Los Diamantes Subdivision Drainage Management Plan

**RE: Los Diamantes Subdivision
Drainage Report, and Grading and Drainage Plan
Engineer's Stamp Date 3-24-2015 (File: N09D013)**

Re: Los Diamantes Subdivision
Revised Engineers stamp date 6-5-15 (N09 / D013)

INLET GOOD DUST WAY CULDESAC TO POND

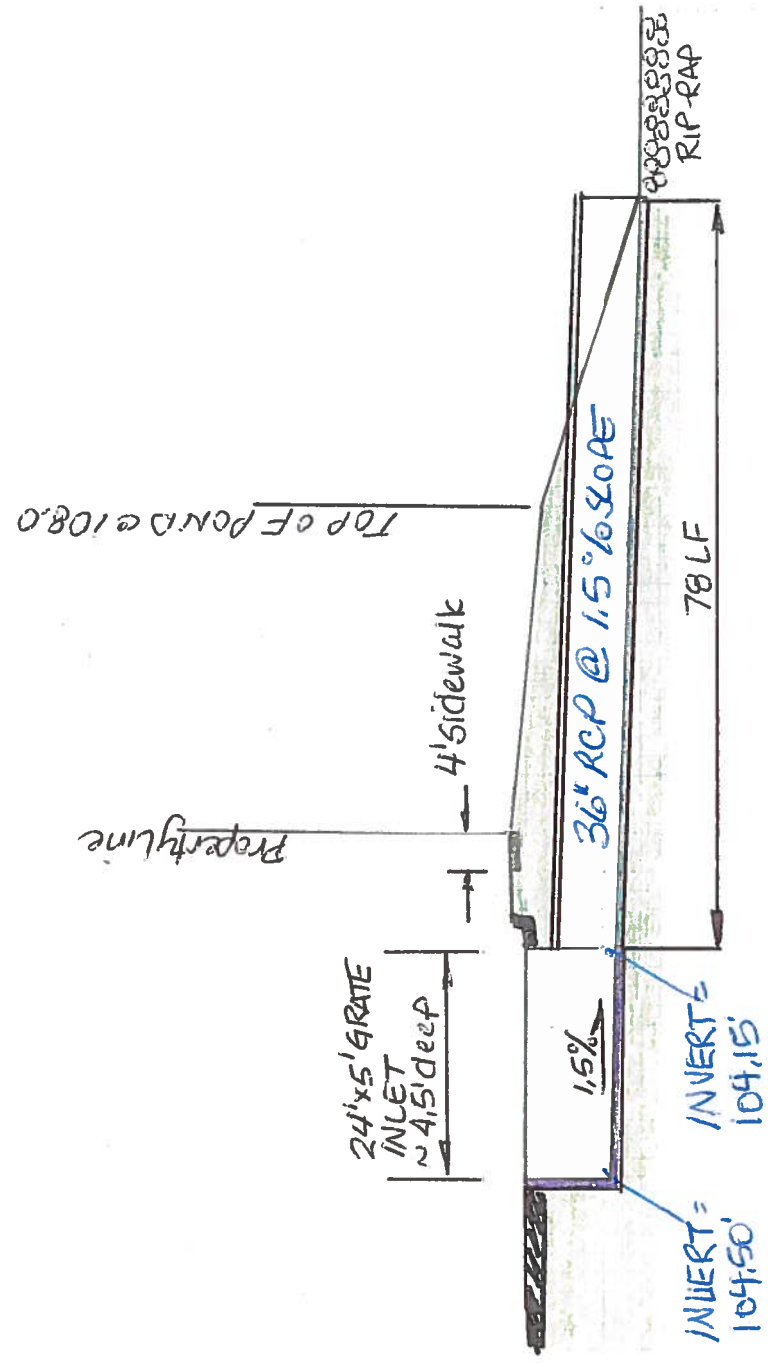
2. It is acceptable to discharge more than the intended 33 cfs into the 30" stub. How is the discharge part of the rating curb calculated in AHYMO? Also show that the 72" SD between MH 16 and 17 has capacity.
3. The grated inlet in Gold dust way Cul-de-sac is not a COA standard. Provide standard inlets.
4. Show Pond Volume on the Plan.
5. If Tract A is intended to discharge into 98th St. in the undeveloped condition, a desilting pond should be shown on the grading plan. Contours show that the SE corner of Tract A is at same elevation as T.O. Curb but view from google earth shows it to be lower than T.O. Curb in that area. Please confirm survey is accurate.

10. The grate shown in Gold Dust Way culdesac is also taken from COA Std dwg 2271 and 2272. It is commonly known as a "cattle guard inlet". I have used these numerous times in other developments. The COA standard details will be modified accordingly to the specific requirements of this project; such as the invert of the channel will be called out as well as the grate elevation and the actual length of the channel.
